DCN No. E010525-01

Document Change Notice (DCN)

DOCUMENT No. (DOC-REV-GP.ID)	TITLE	NEW REV
D990694-B (PCB)	LSC Whitening Filter Rev B PCB Modification	B1

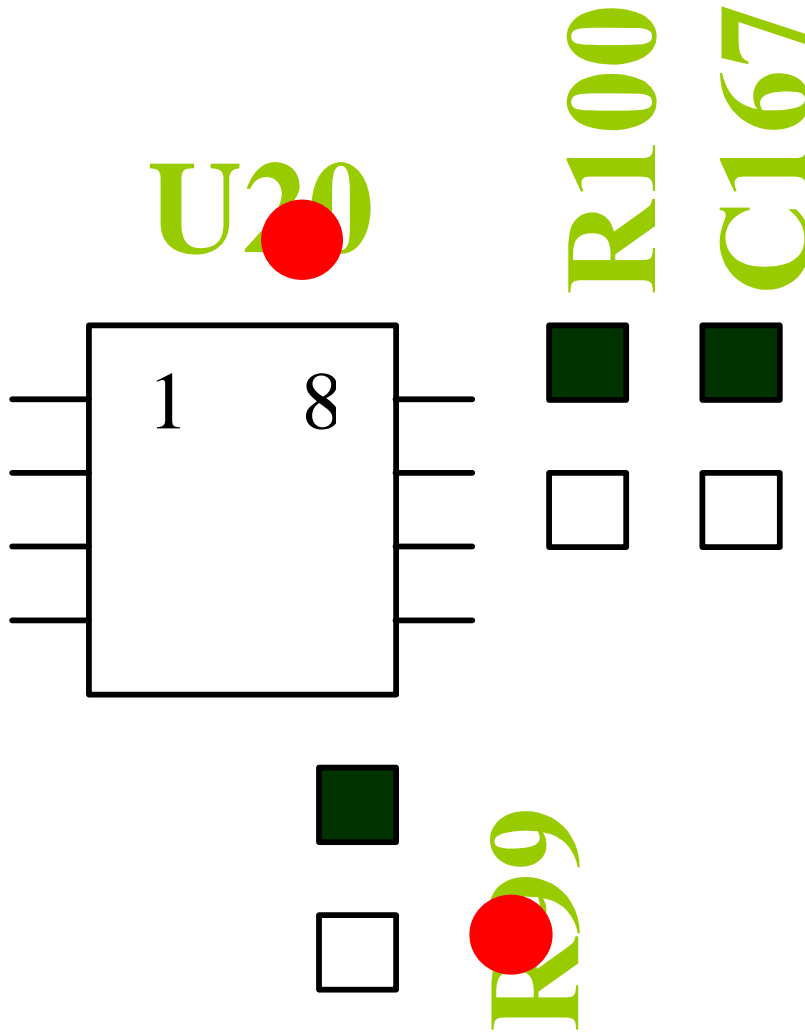
The poorly routed trace is removed from the circuit and replaced with jumper wires. Via removal is accomplished by hand using a 40 mil drill bit. Do not drill through board as internal planes may be shorted or internal traces may be cut.

1. Remove (top layer only) via pad under the "2" in "U20" silkscreen.
 2. Remove (top layer only) via pad on first "9" of "R99" silkscreen.
 3. Place wire from pad of R100 to pad of C167 (pads across from U20 pin 8).
 4. Place wire from pad of R99 (pad closest to U20) to pads connected in step 3.
- See figure on page two.

REASON FOR CHANGE: Severe cross coupling to channel 5 caused by poorly routed traces on the board. Schematically the board is correct, but the connections were poorly routed.

Remove red  vias.

Connect black  pads.
